August 29, 1980  
TLL 421

Three Mile Island Nuclear Station, Unit 2 (TMI-2)  
Operating License No. DPR-73  
Docket No. 50-320  
Organization Plan Revision 1A

FIGURE 1.2

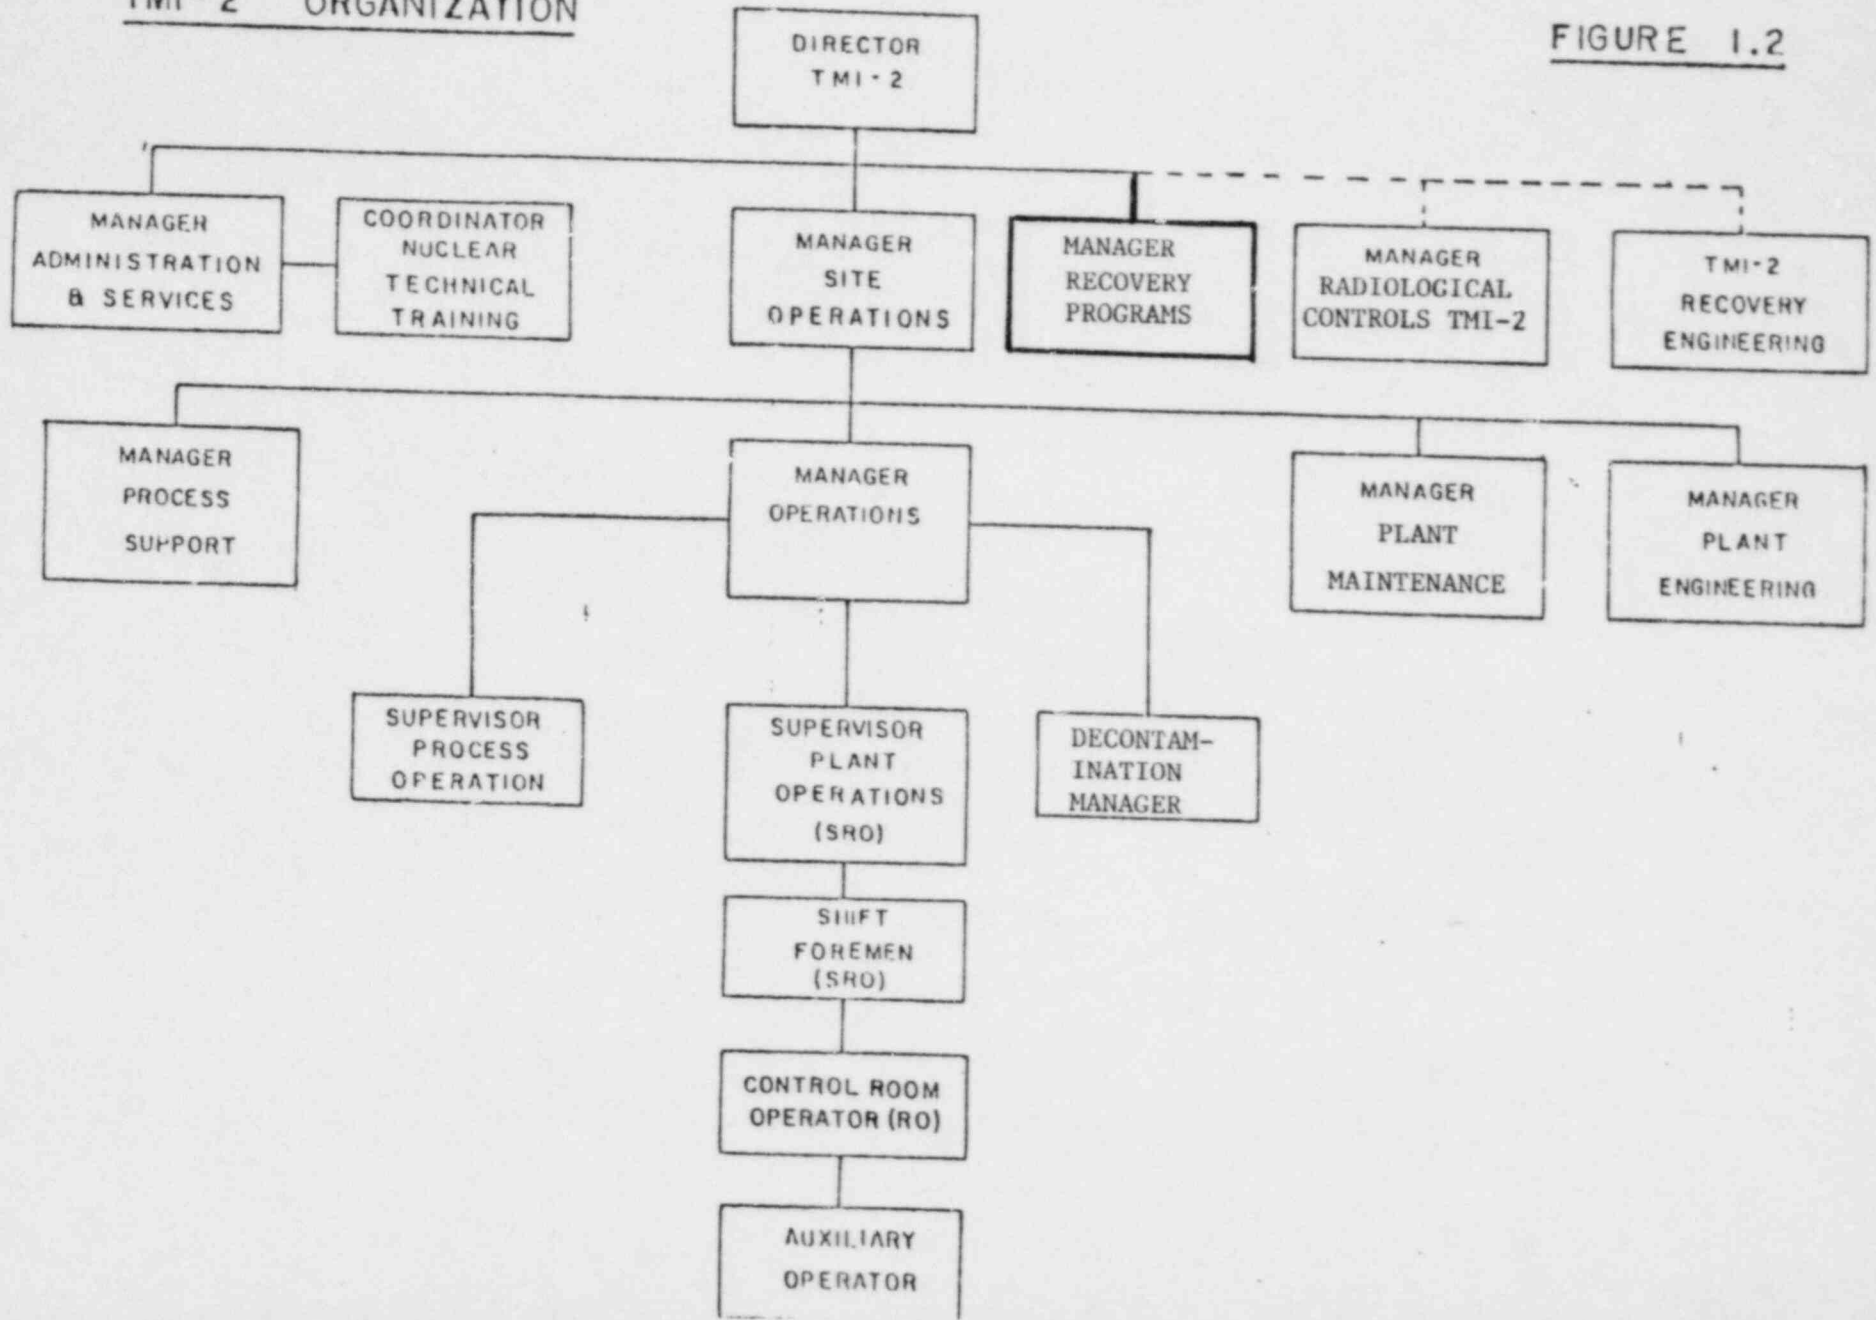
The Manager Operations, in addition to the management of process operations for decontamination and the facility decontamination, is responsible for shift operations. He is assisted by the Supervisor of Plant Operations who provides direction for shift personnel. The minimum shift personnel is specified in Section 6.2 of the TMI-2 Technical Specifications.

The Manager Process Support provides planning and engineering support for the decontamination processes in use during the recovery of the plant.

The Manager Plant Engineering provides component and system operational evaluations as well as the required detail engineering support for the implementation of recovery systems. The Plant Engineering group is composed of nuclear, mechanical, electrical, chemical, and instrument and control engineers.
